# Revised Analyses of Decommissioning for the Reference Pressurized Water Reactor Power Station

Effects of Current Regulatory and Other Considerations on the  
Financial Assurance Requirements of the Decommissioning Rule  
and on Estimates of Occupational Radiation Exposure

Final Report

Prepared for  
U.S. Nuclear Regulatory Commission

Figure C.2 Flow diagram for entering data into the CECP

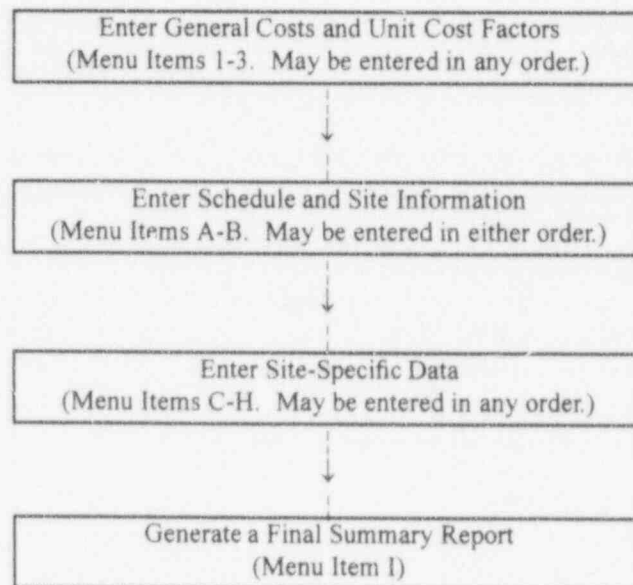
- 006-6 Comment: Section C restates verbatim much of NUREG/CR 6054. Consideration should be given to deleting this section from -5884; all discussion of the Cost Estimating Computer Program more appropriately belongs in 6054. If section C were deleted, the two volumes of NUREG/CR-5884 could be consolidated. (Furthermore, Figure 2.2 of 6054 is inconsistent with Figure C.2 of -5884 regarding sequence of data entry for menu items A, B, and C.)

Figure D.2 Present value costs for SNF storage operations

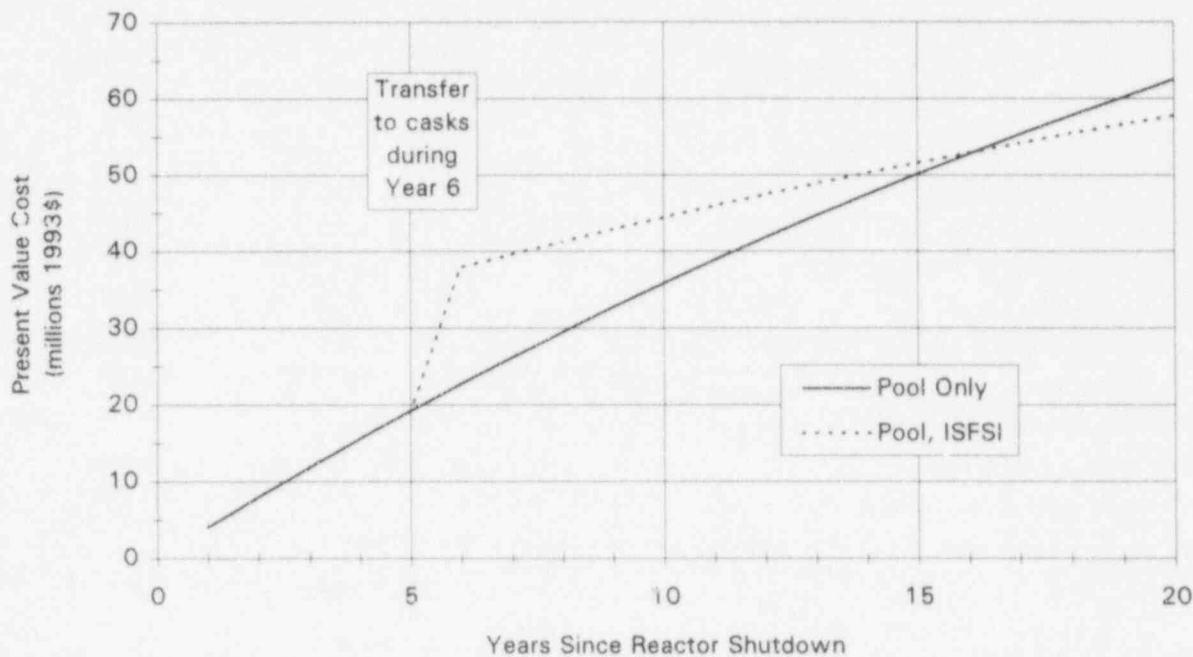
- Comment: Figure D.2, which compares the present value cost of the pool option vs. the ISFSI option, does not present a valid comparison. First, the use of the 3% discount rate distorts the comparison. Second, the assumptions favored the pool option more than the ISFSI option. Third, and most importantly, the comparison does not address the impact on the overall decommissioning cost and schedule.

- Response: The revised Figure D.2 illustrates the cumulative present values of the costs for SNF storage, using either the pool-only approach or the pool + ISFSI approach. The net result of the analysis would tend to favor pool-only storage for the first 16 years. If the inventory remains greater than zero beyond 16 years, the ISFSI approach becomes more cost-effective. The estimated annual cost for safe storage operations during the pool storage period are about \$936 K in constant 1993 dollars. Thus, the D&D costs would increase by that amount for every year that the pool remained in service.

Figure E.1 Upper core assembly

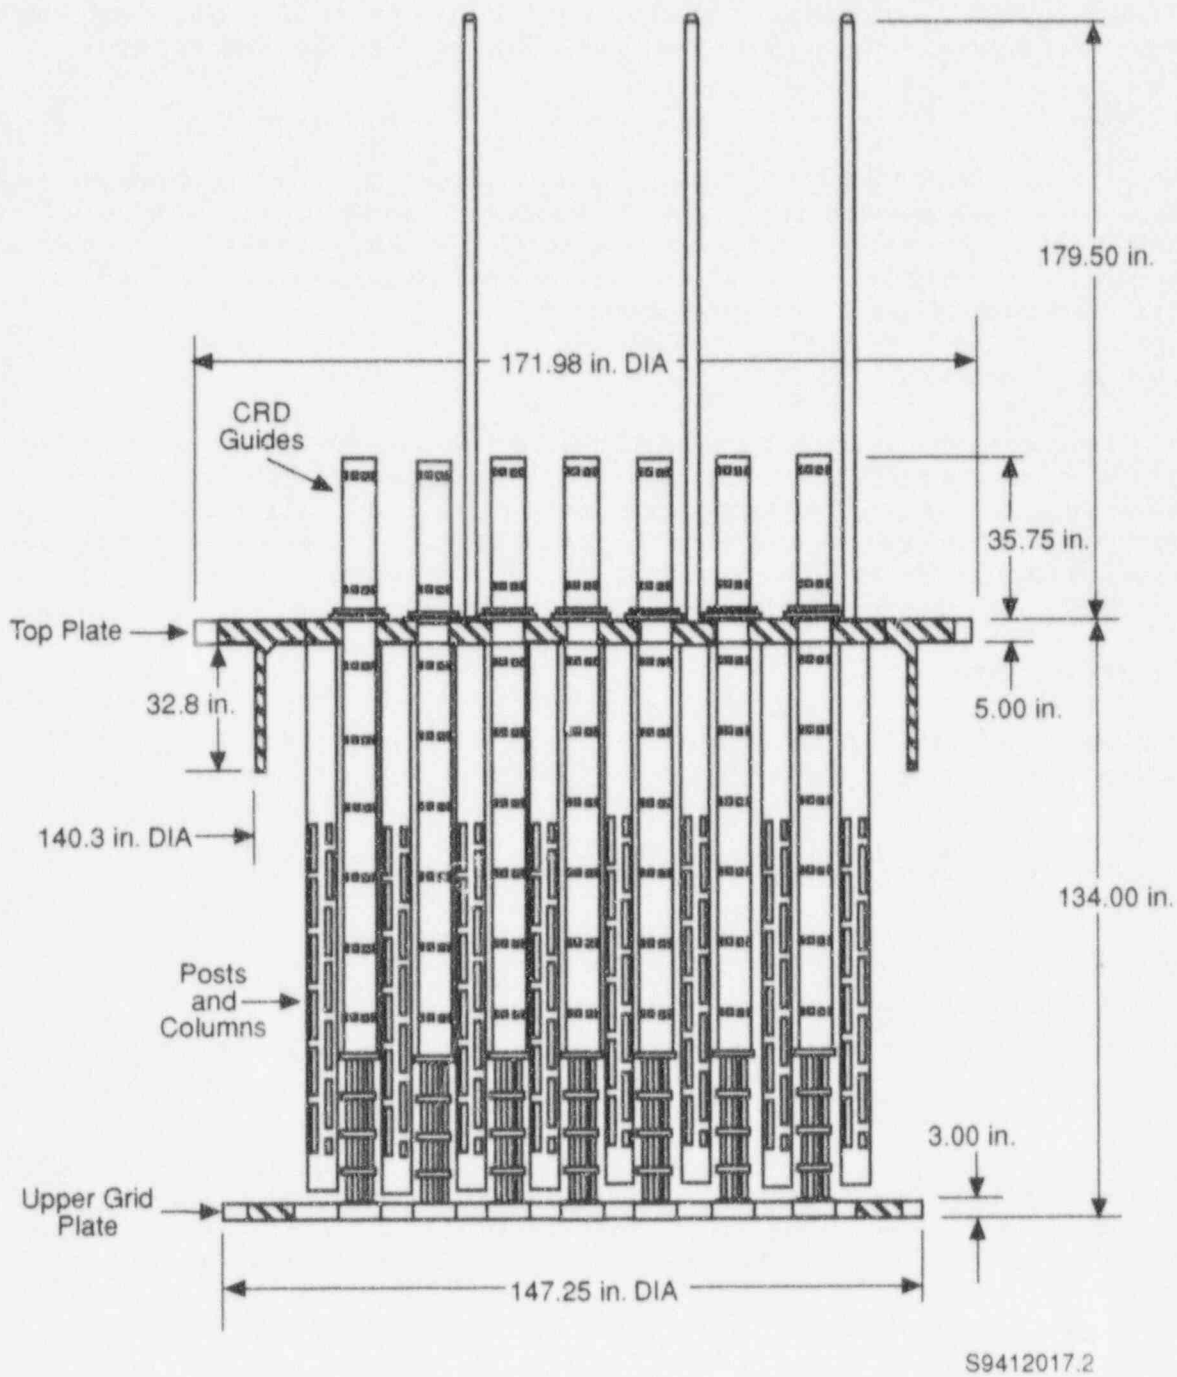
006-7 Comment: Section E describes the components of the reactor and internals. Figures E.1 and E.2 show many of these, but not all components are labeled and the names of those which are labeled do not always have the same names used in the text.
